TOWN OF PALM BEACH

TOWN COUNCIL MEETING DEVELOPMENT REVIEW

AGENDA

FEBRUARY 10, 2021

FIRST LEVEL FLOOR PLAN - PROPOSED

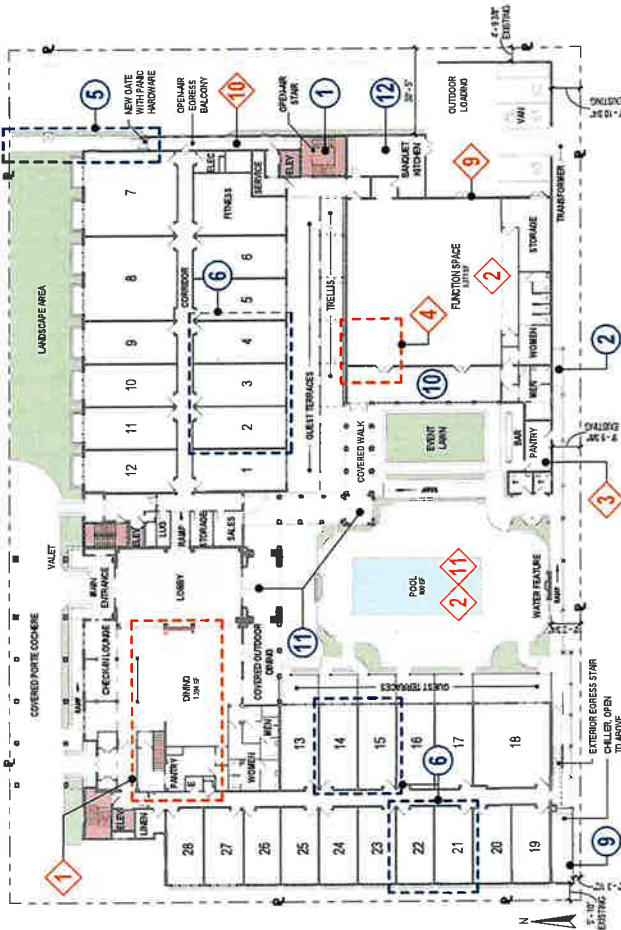
- A. The Application now includes a “Function Service Building” which is contiguous to a portion of the East building face of the Function Room. (See Exhibit “4,” Plan Sheet A-104) Our client objects to this expansion to the Function Building, as it increases the activity of the Site along the East property line. The Function Service Building’s supportive activities (especially activities related to cleanup and removal of Function Room Events) will likely be after dark, and both noise and vehicle light will be caused by loading area activities (from vehicles turning in the loading area shown on the Site Plan, or being used to transport equipment, furnishings, food, and beverages into either the Function Room or Function Service Building).

DATE: 10-10-2020
JOB NO.: 20-100
SHEET: 1 OF 1
DRAWING NO.: SP-1.02

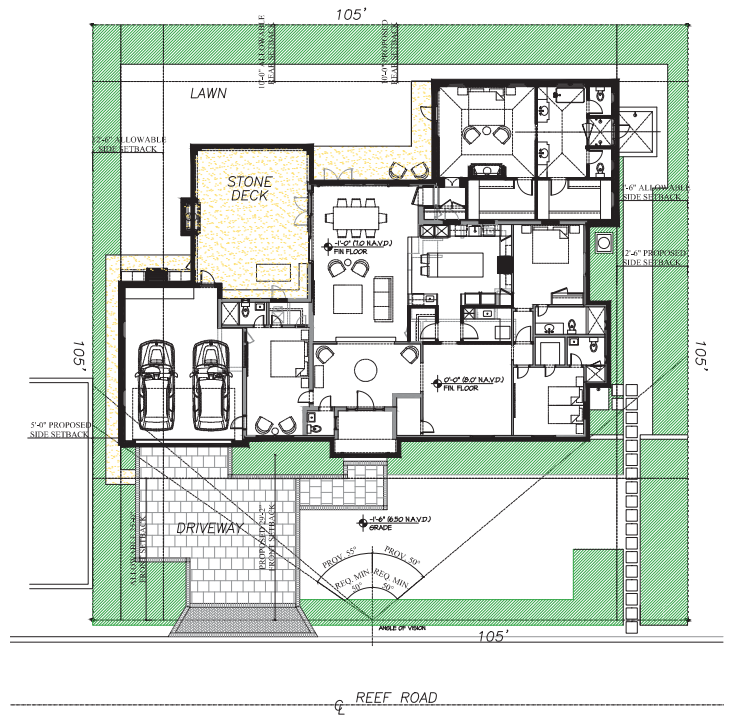
Our office represents Gayle Peterson, the owner of 151 Reef Road directly west of and adjacent to 143 Reef Road. As set forth in our prior correspondence dated September 4, 2020 (a copy of which, without exhibits, is attached hereto) Ms. Peterson continues to believe that the Applicant does not meet the requisite standards and hardship needed for a variance for its proposed garage whether designed as the previous 2 car garage (at 20 feet in width) or now a 1 ½ car garage (at 16 feet 10 inches). As such, she continues to oppose Plan A of the presentation sheets (Sheet A-1.02a) which requires a variance for a reduced 9 foot setback in the side yard between her property and the Applicant's.

However, it appears that in the Applicant's Plans there is also a Plan B (Sheet A-1.02b) (attached hereto) which requires no variances as to the side yard setback or angle of vision. At the same time, it incorporates a generator and apparent AC Units in the side yard. To the extent there are no variances required for the garage and the AC and generator meet the proper Code Standards (i.e. for setbacks in the RB Zoning District and screening walls), Ms. Peterson would accept that arrangement. Thank you.
